ALTOONA CITY PLANNING COMMISSION

Regular Meeting of Tuesday, August 1, 2023 at 3:00 PM
4th Floor City Hall Common Room

At the request of the City of Altoona, we have completed our review of the subdivision and land development plan for the above referenced project. The following information was provided to our office on 06/15/2023 for review of a subdivision and land development located at 601 Logan Boulevard in the City of Altoona, Blair County:

Re: All Washed Up Auto Spa-Logan Blvd, Altoona, PA
Land Development Review-Response Letter 1

SITE PLAN

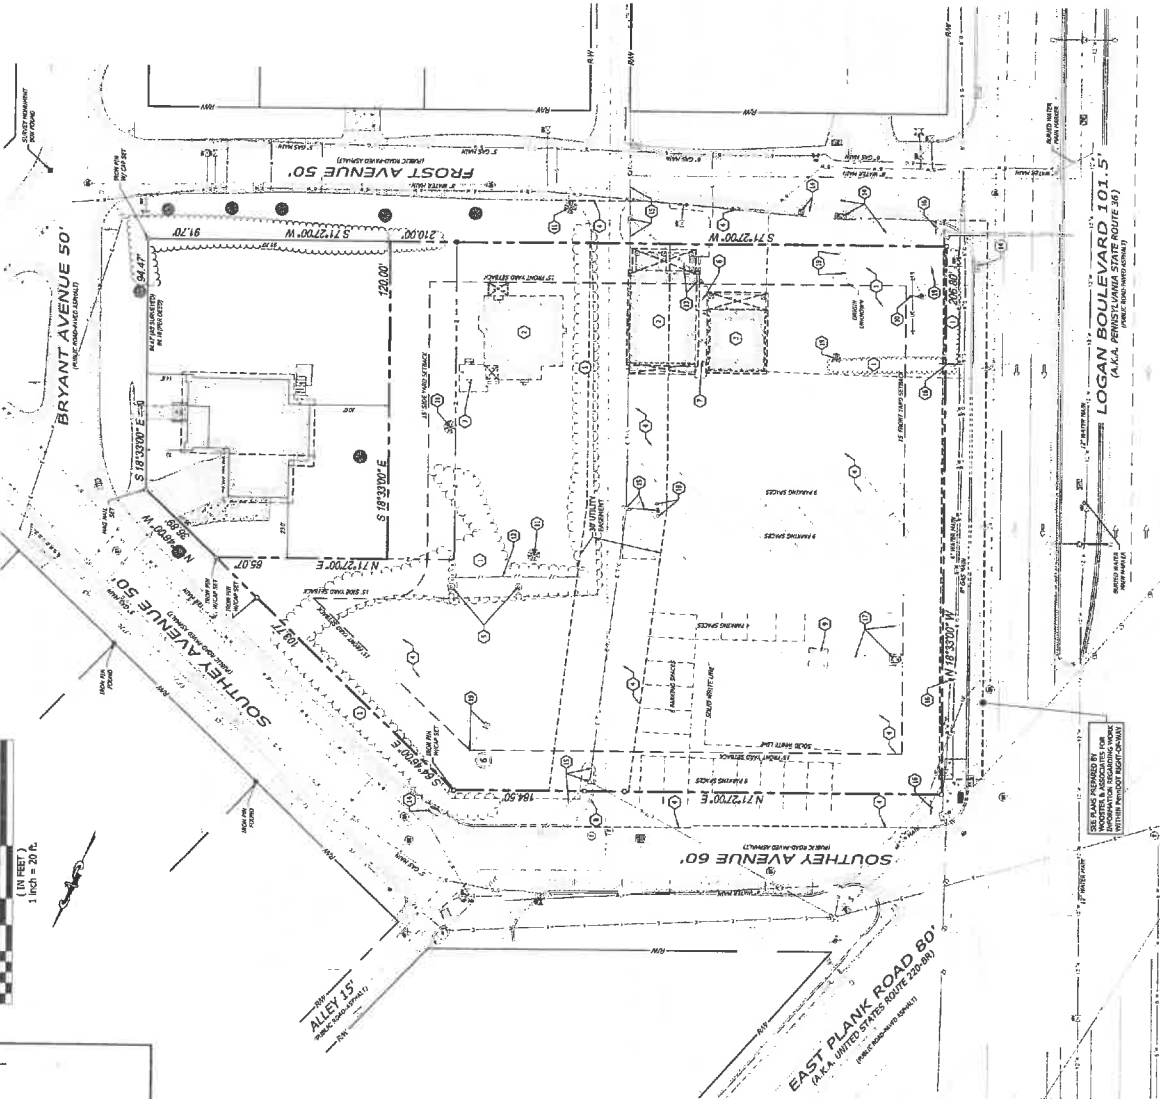
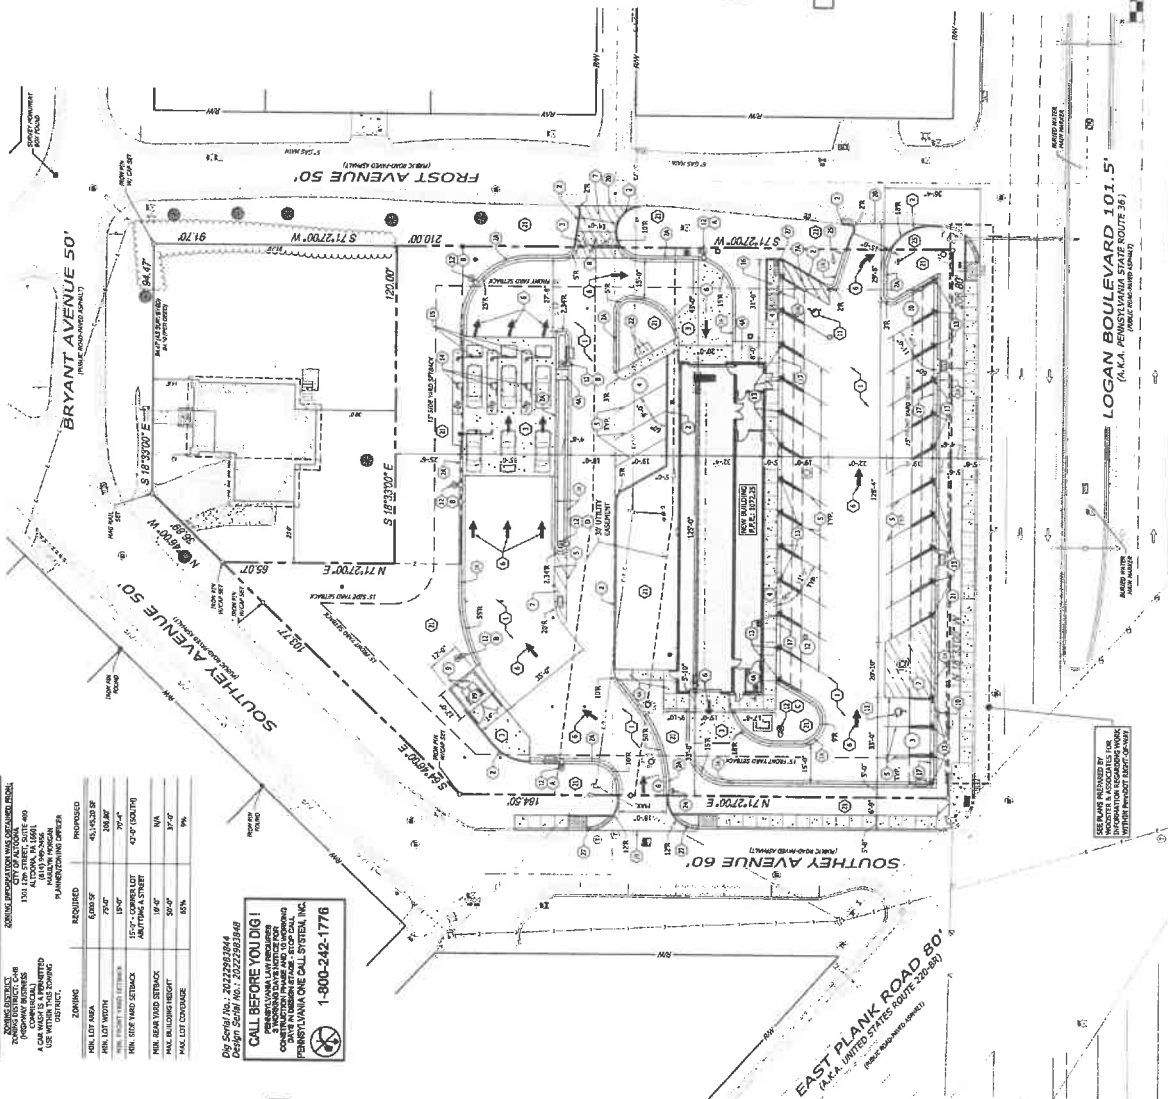
34. 640-64.A(2) All Sidewalks shall be constructed to provide adequate access to the physically disabled.
 - On the ADA ramp on the interior of the property by the building, it appears that the depressed area/DWS is in an area that would be blocked by a parked vehicle. Please shift to the end.

- DWS in the Right-of-Way to be Brick Red Composite. ***Response: See revised keynote 27 of sheet SP02 denoting DWS color.***

37. 640-65. E (6) Lighting shall conform with this section including height, cut-off fixture, etc. Enough detail should be added to the plan set (that will be recorded) to show conformance with this section. **Response: Please see revised sheet SP-2 and sheet SP-5A showing light locations, types and mounting heights.**
